# Addendum #1

Attn: Estimator	Date: February 21, 2024
From: Lisa Donahue, Project Administrator	Pages: 92 (including cover page)
Re: Bay City Public Schools	Project: 2024 SF BP 11 – Eastern HS at Handy MS
CC:	Proj. #: A23904

PROJECT TITLE  
 RENOVATION FOR BCPS:  
**BAY CITY EASTERN HIGH SCHOOL AT HANDY M.S.**

SHEET NUMBER  
**A2.21**

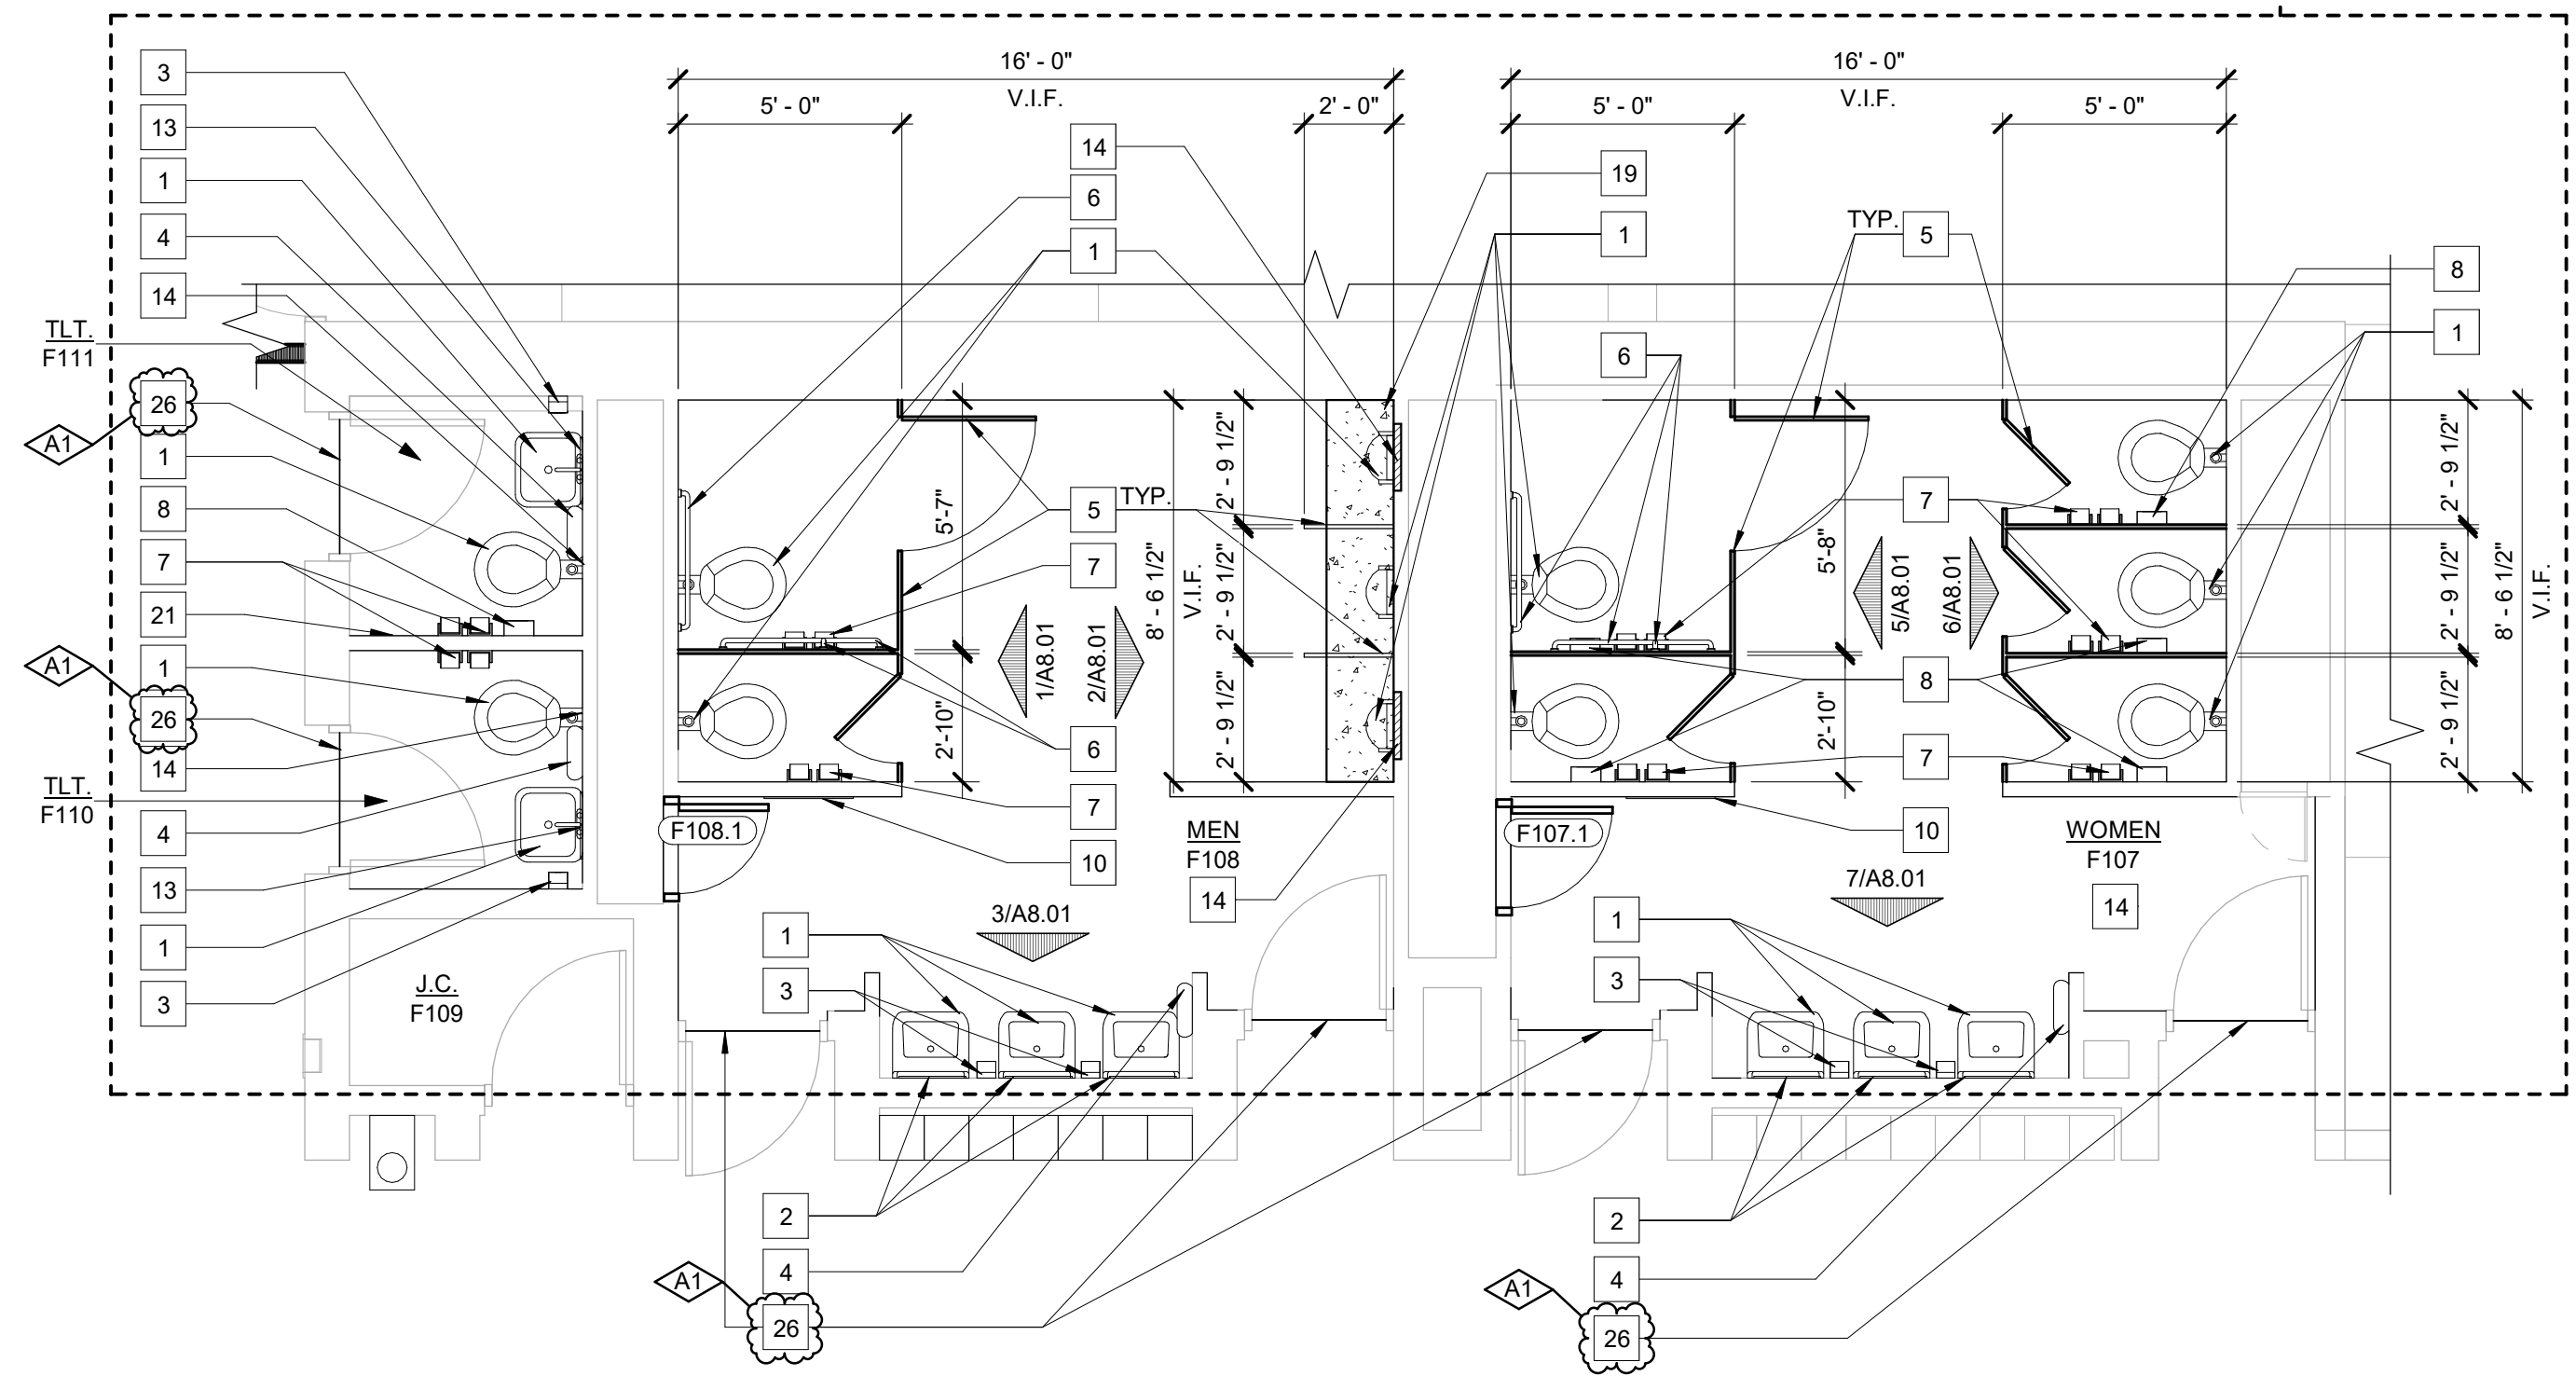
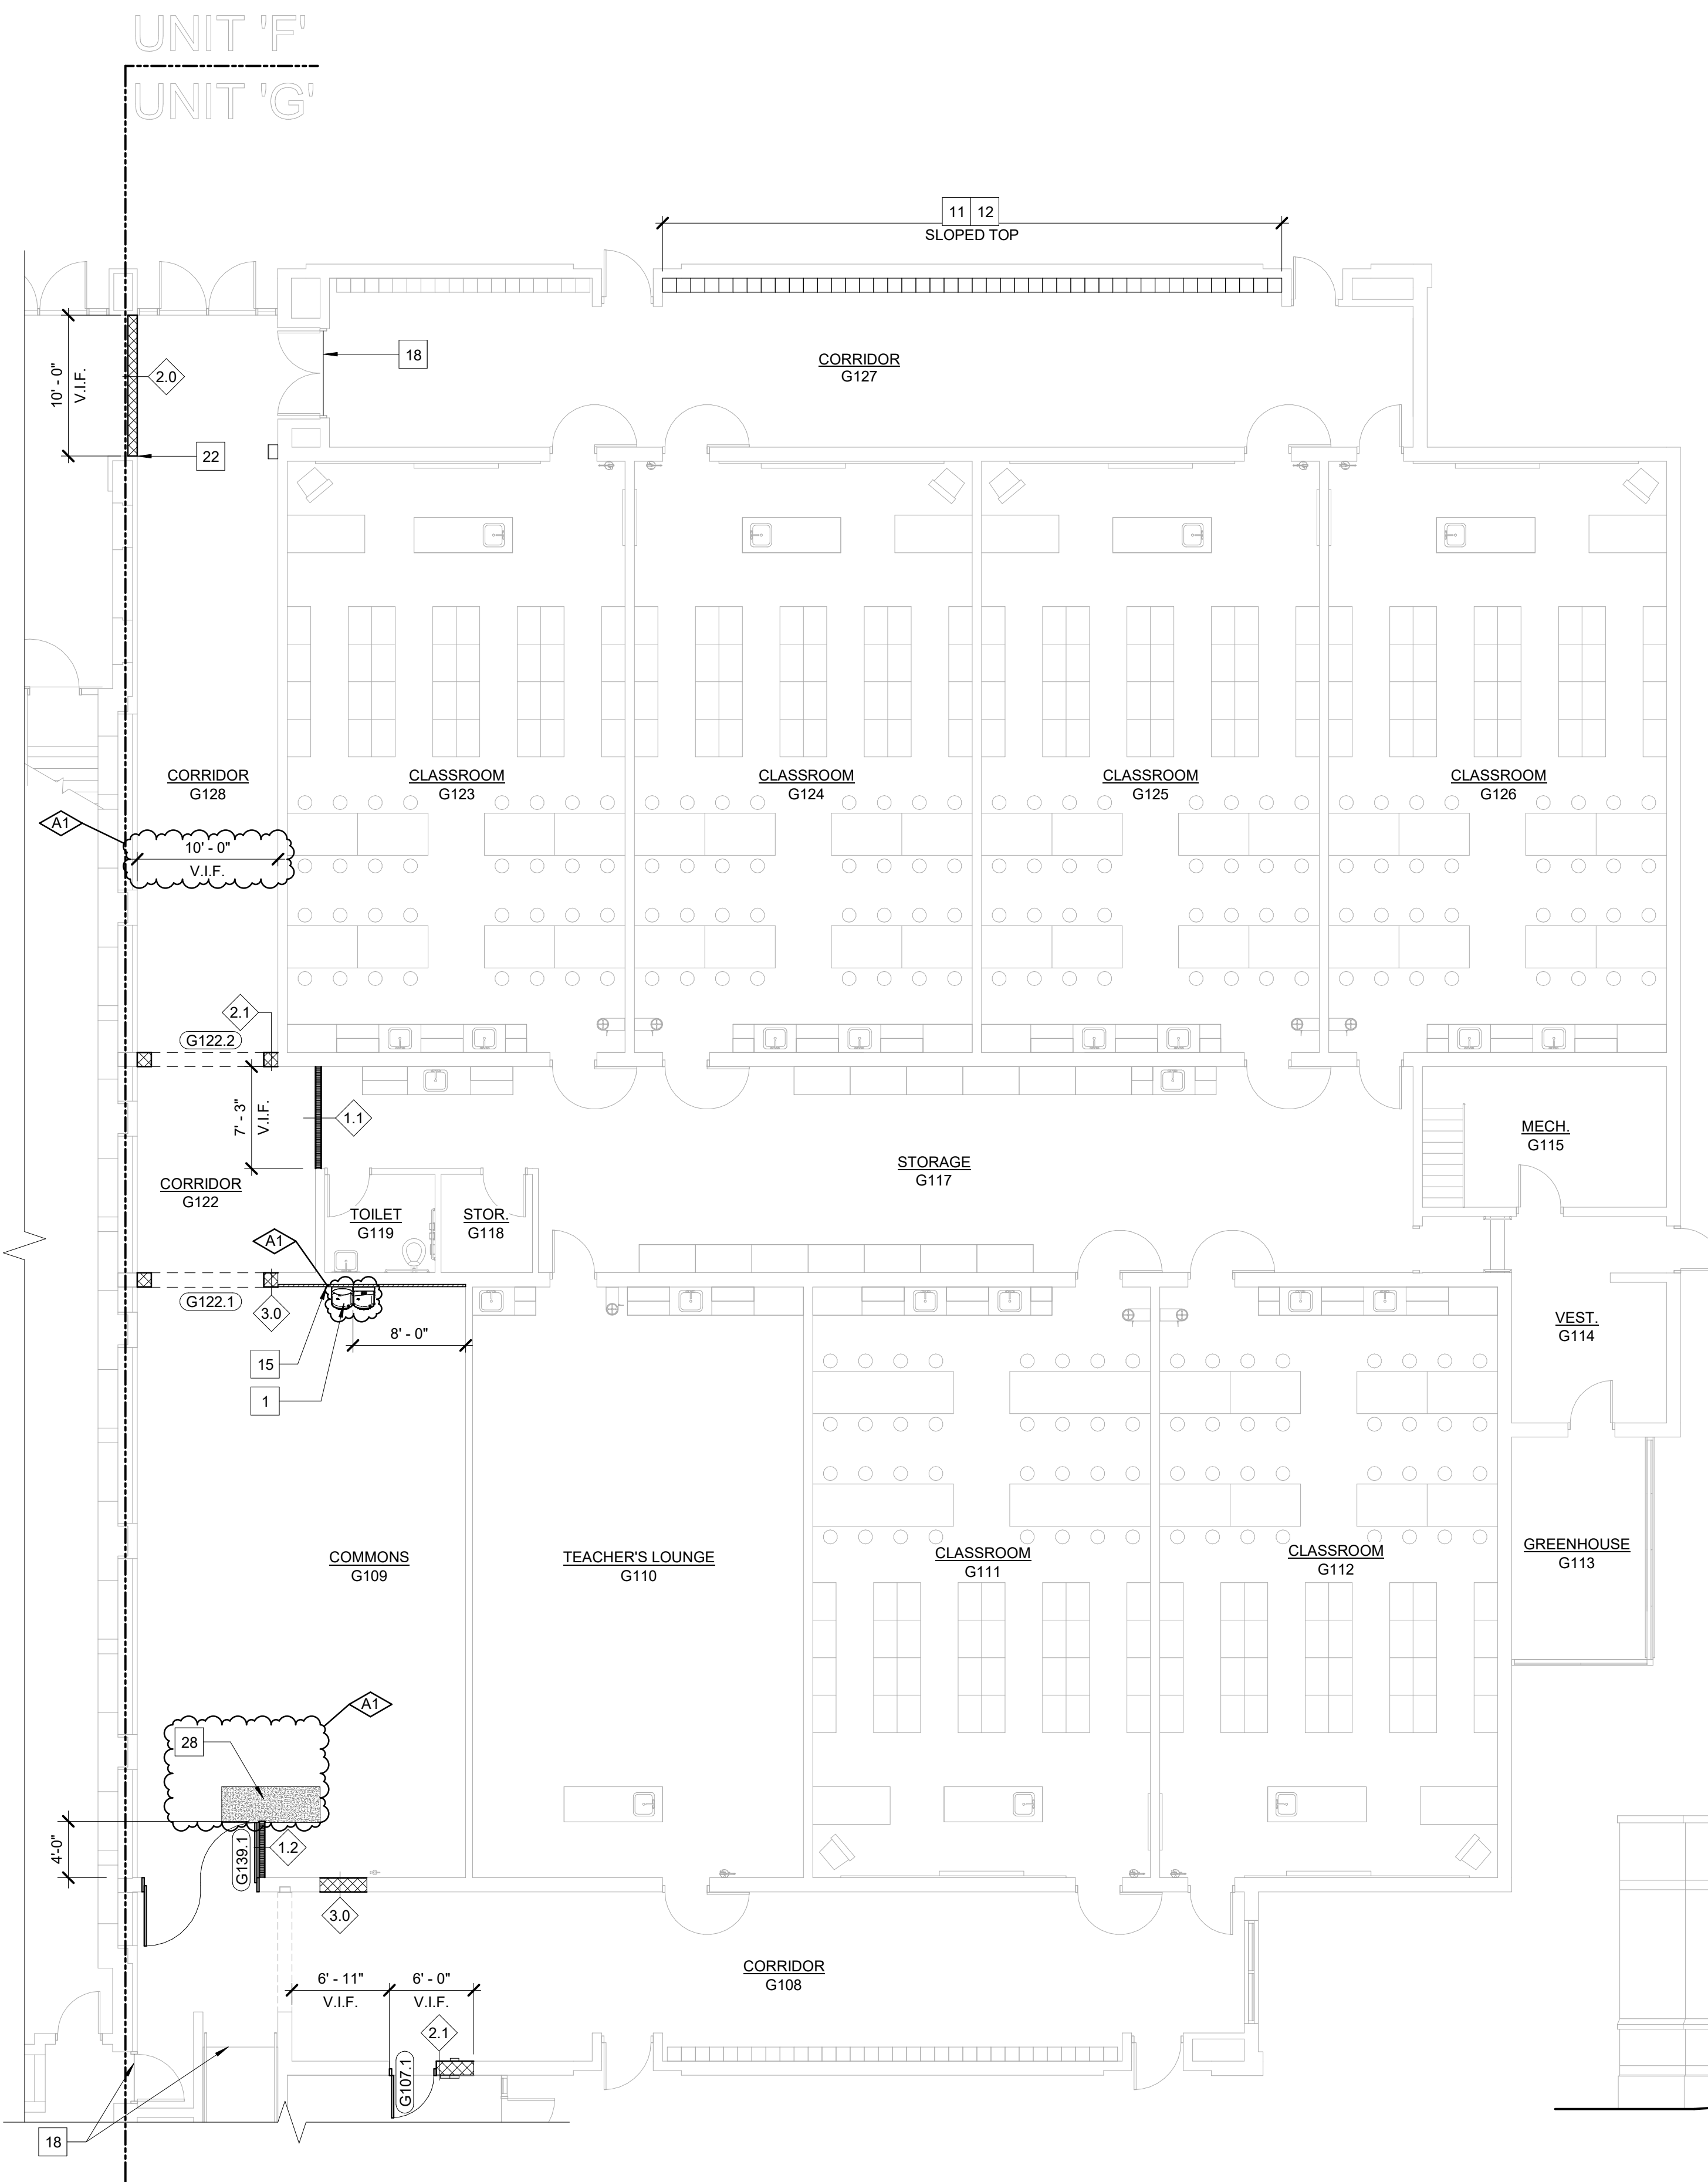
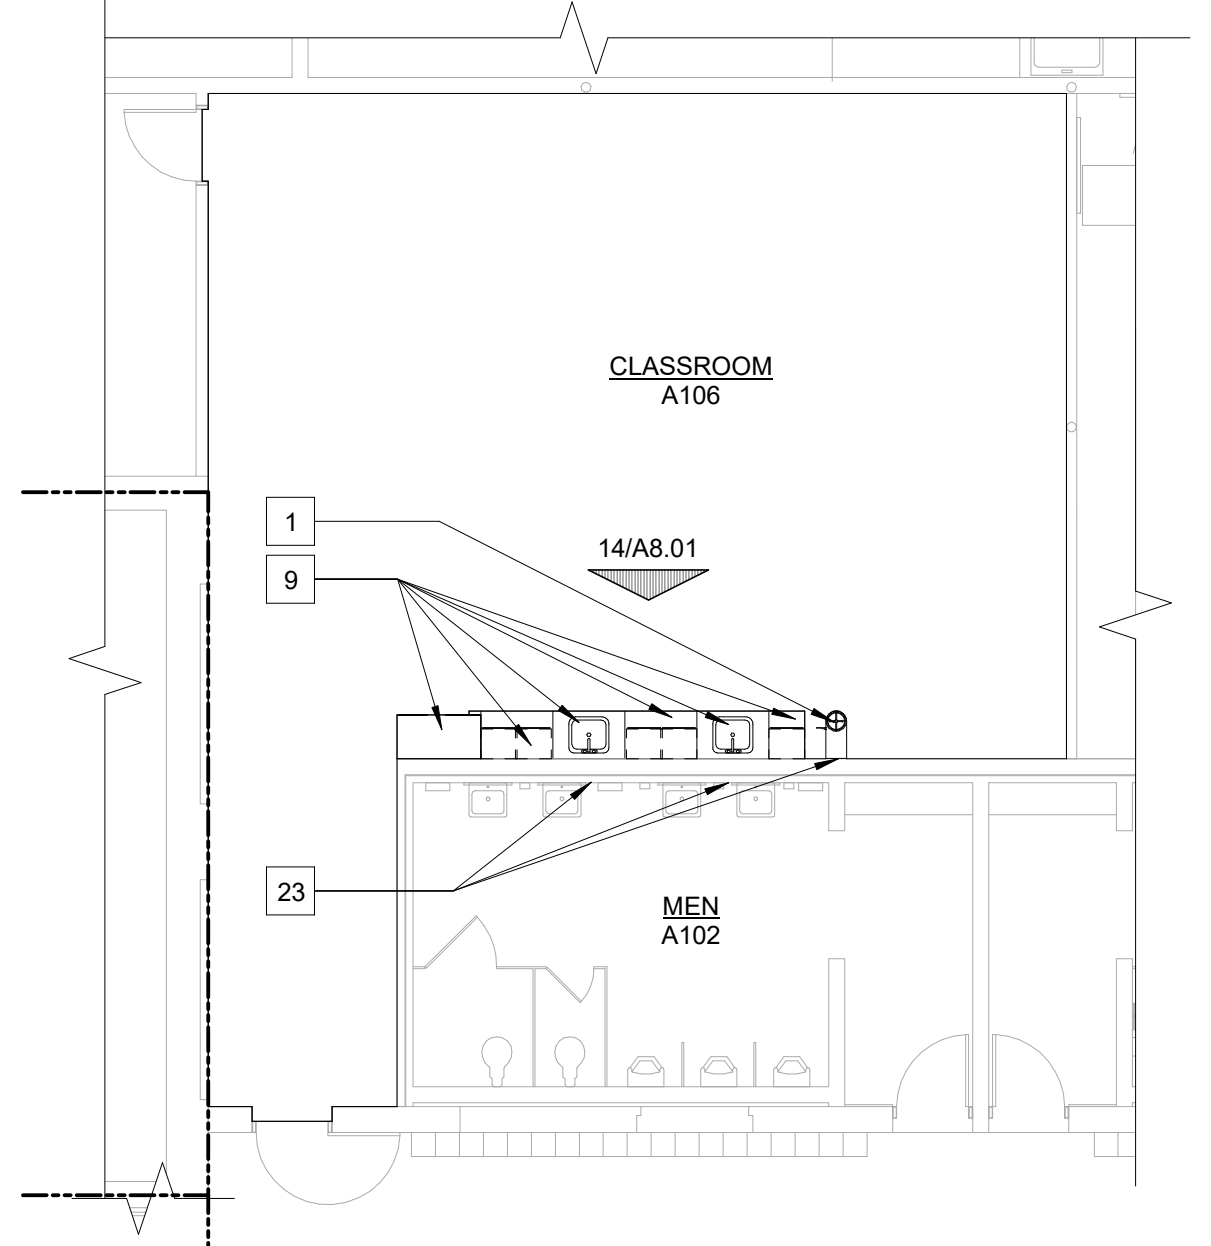
- A. Added aluminum tapered transition at toilet room doors per Alternates 3 & 4.
- Item A4: Reference Section 012300 & Sheet TS (Re-Issued)
- B. Alternate No. 3 revised to include flooring scope.

Item A8: Reference Sheet A2.21 (Re-Issued)

- A. Deleted transition strip at door G139.1.
- B. Revised keynote #21 to patch and repair existing wall after removal of wall mounted dispenser in lieu of "<varies>".
- C. Added keynote #26 to add tapered aluminum transition strips to toilet room doors.
- D. Added keynote #27 for grommets in Recept. (G129B).
